**TOWN OF MOUNTAIN VILLAGE
REGULAR DESIGN REVIEW BOARD MEETING AGENDA
THURSDAY JUNE 2, 2022 10:00 AM
MOUNTAIN VILLAGE TOWN HALL
455 MOUNTAIN VILLAGE BLVD, MOUNTAIN VILLAGE, COLORADO
TO BE HELD HYBRID THROUGH ZOOM:**

5.	10:35	30	Ward/ Applicant	Quasi-Judicial	Consideration of a Design Review: Final Architecture Review for a new Single Family detached condominium on Lot 161D1, Unit 17, 6 Tunnel Lane, pursuant to CDC Section 17.4.11 and 17.5.16.

6.	11:05	30	Miller/ Applicant	Quasi-Judicial	Consideration of a Design Review: Final Architecture Review for a new Single Family Detached Condominium on Lot AR-53-R1, TBD Adams Way, pursuant to CDC Section 17.4.11.

7.	11:35	30	Miller/ Applicant	Quasi-Judicial	Consideration of a Design Review: Final Architecture Review for a new Single Family home on Lot 89-3A, 99 Lookout Ridge, pursuant to CDC Section 17.4.11.

SHEET
A1.1
Unit AR-53R1

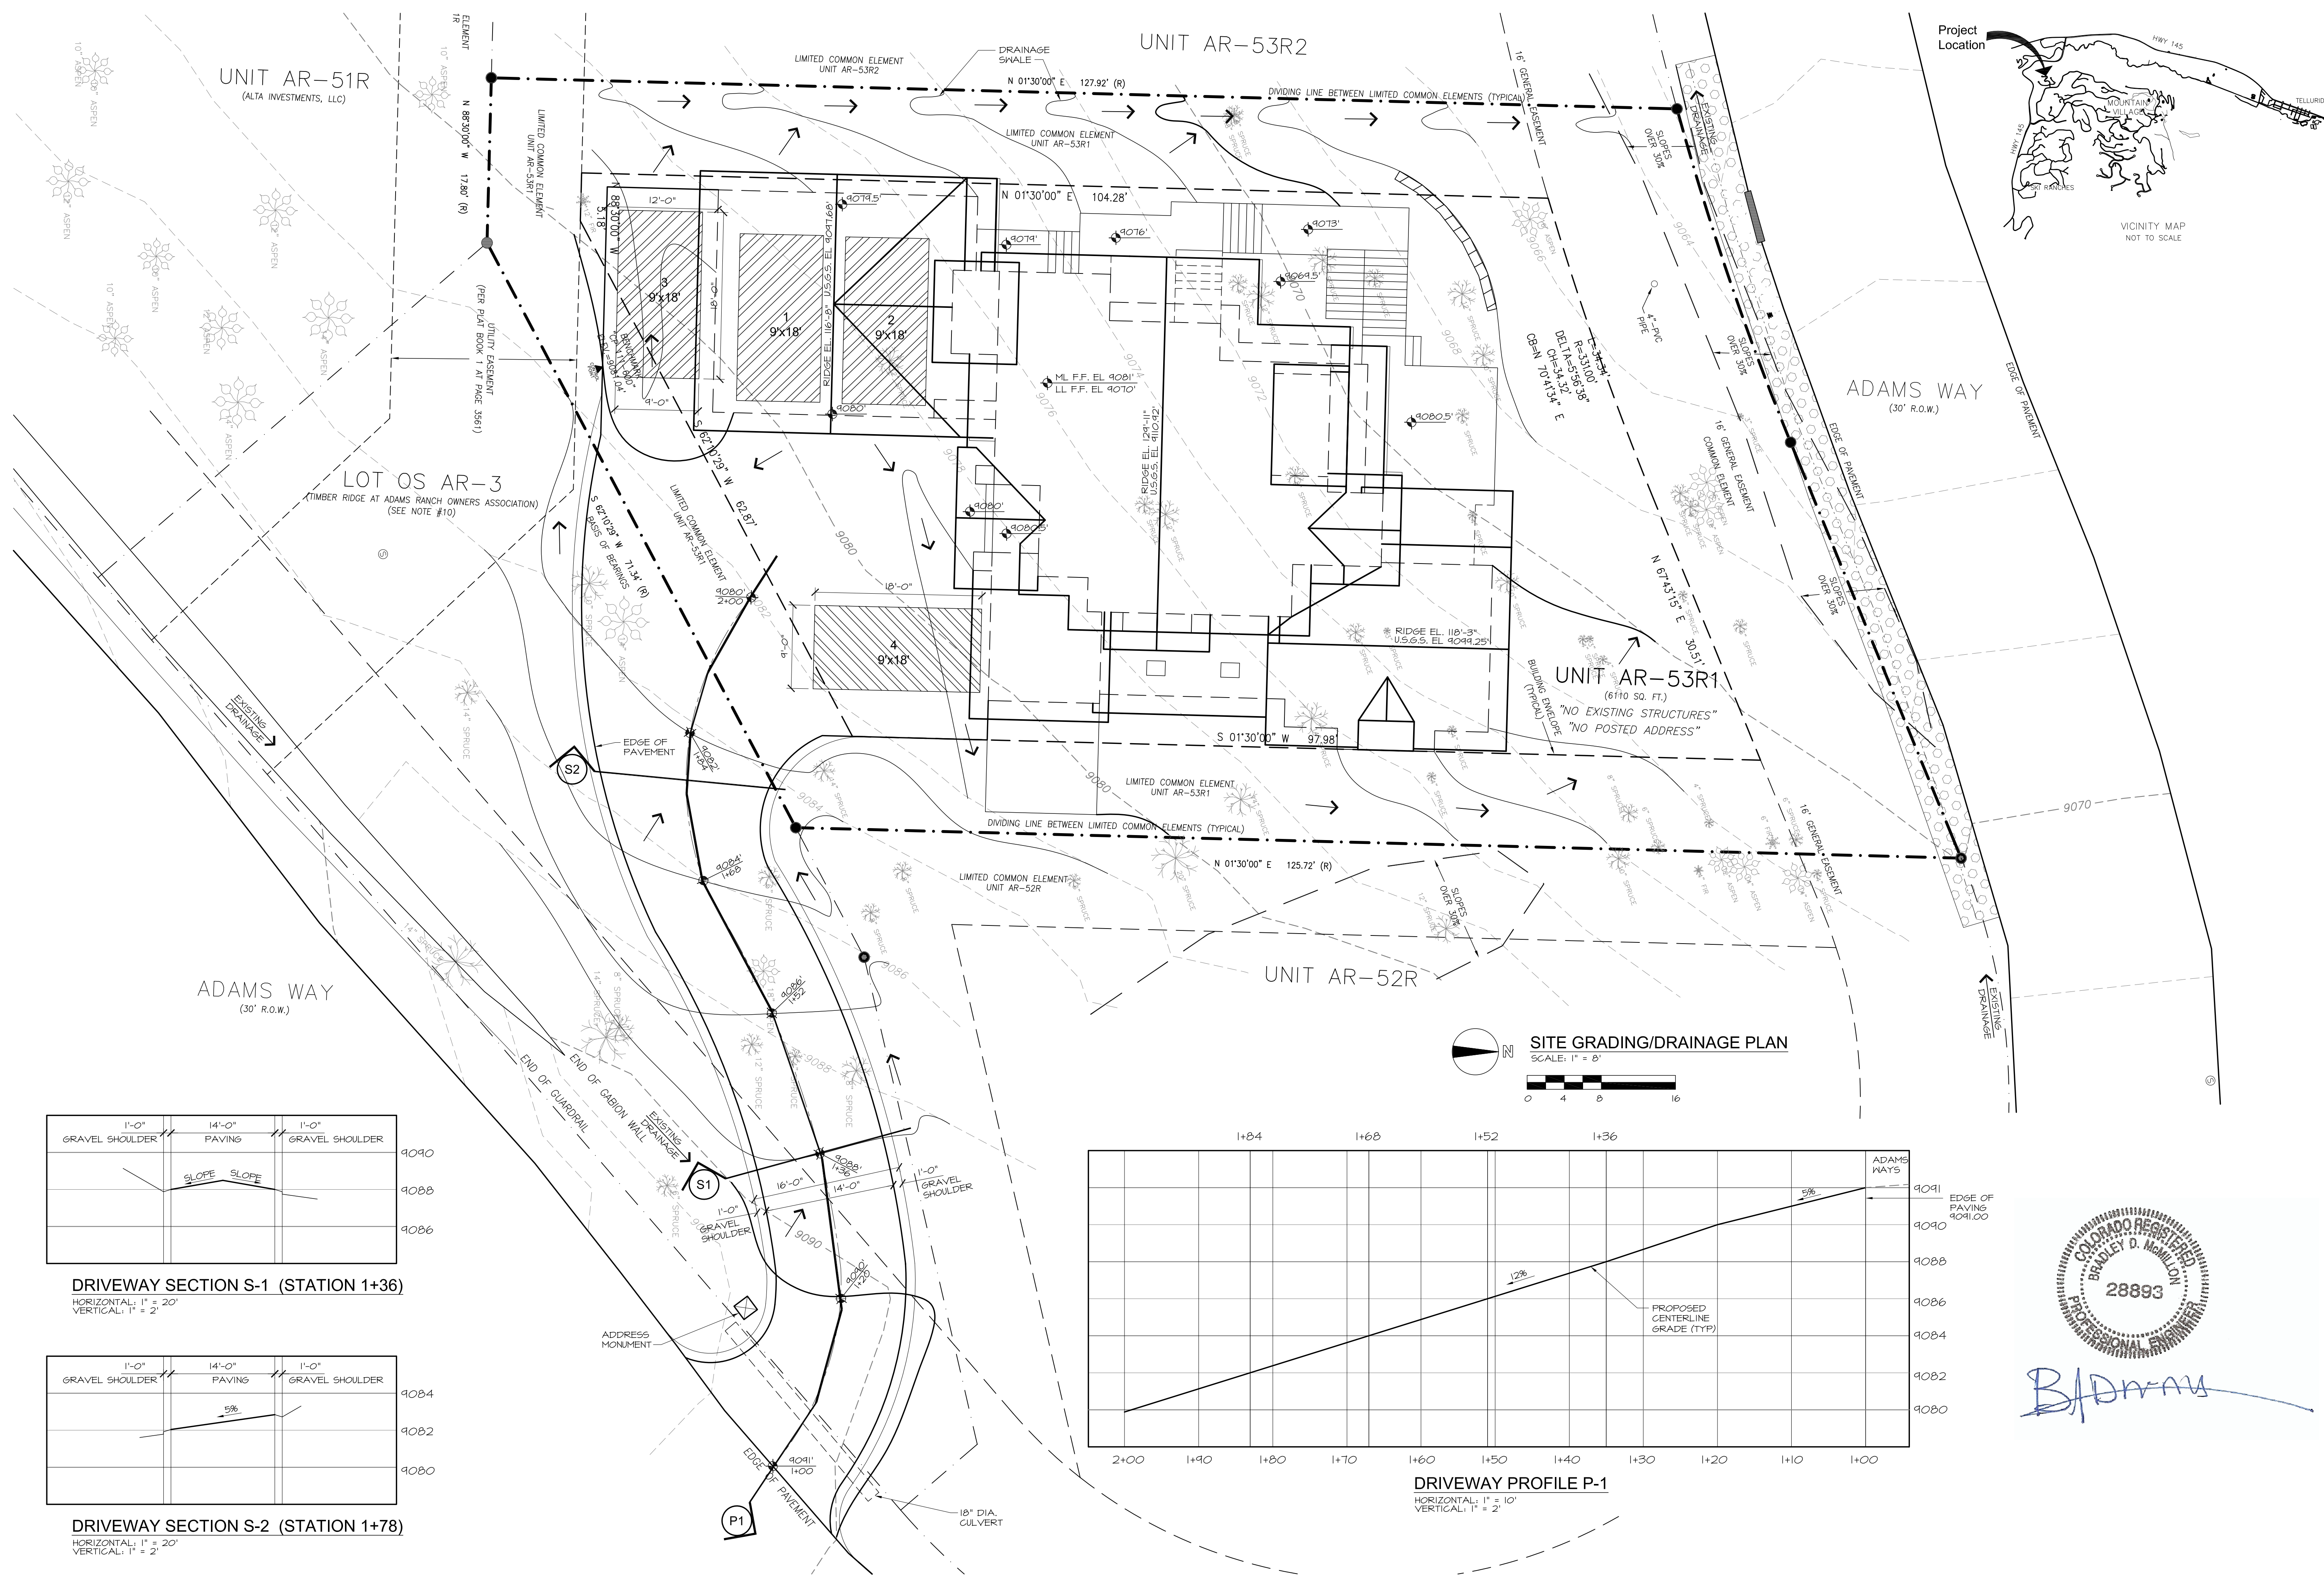
As the General Contractor for the neighboring lot AR-53R2, I have reason for concern after reviewing the drainage plan as shown on Architects Collaborative Sheet A1.1. The plan shows all the runoff from the site and roofs running directly across the shared property line and on to my client's property. This, in general, is not recommended and I strongly feel that this drainage plan should slope to the north and away from the adjacent lot. A drainage swale on the applicant's property should address the concern and route the water to the street to the north. As always, your consideration is appreciated.

ELEVATION - SOUTH/HEIGHT CALC'S
SCALE: 1/4" = 1'-0"

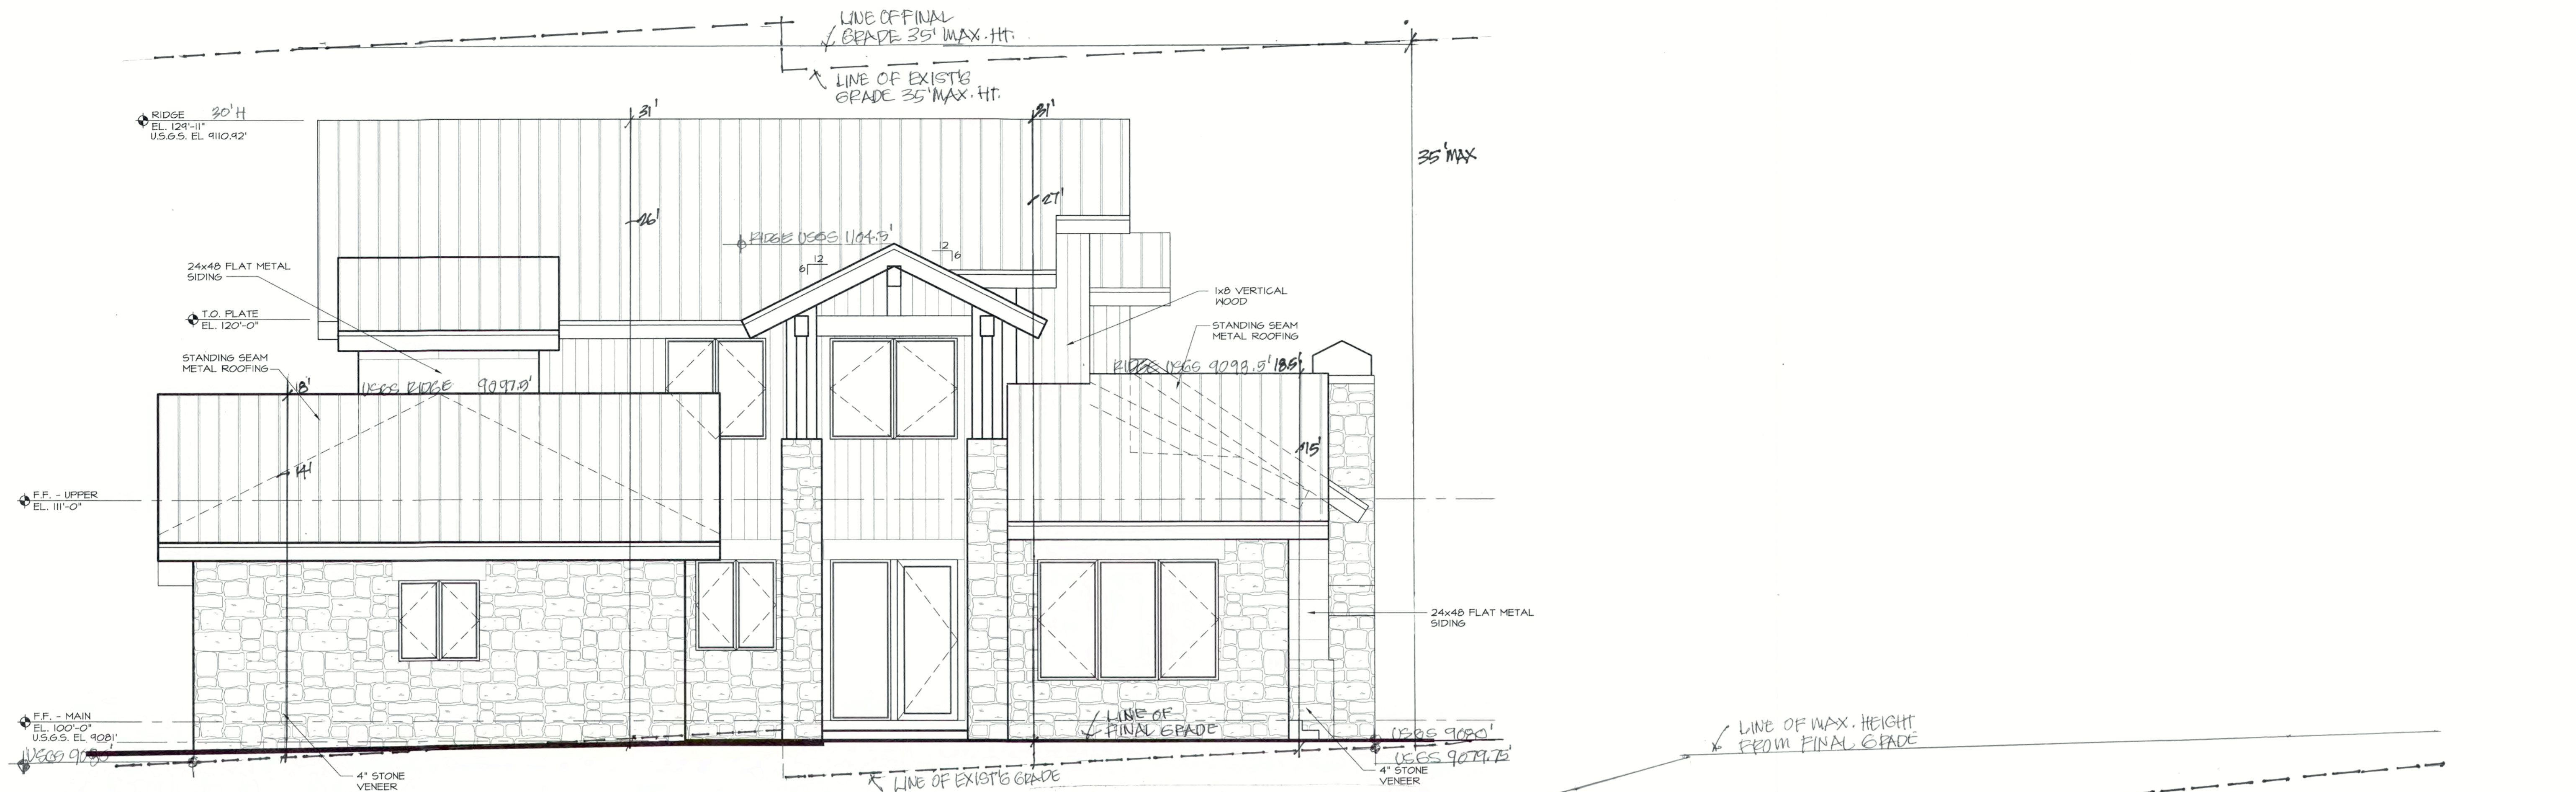
The south elevation of the home (shown on page A3.2) is showing a change in the fenestration that was not captured in the bubbled redline. The windows are showing less dividers than what was proposed at initial. This is the primary elevation facing Mountain Village. Staff does feel that the current way of braking up this glass area is more logical and visually appealing than what was previously show, but it does seem likely that there will be some light spill from within the home given the large expanses of glass.
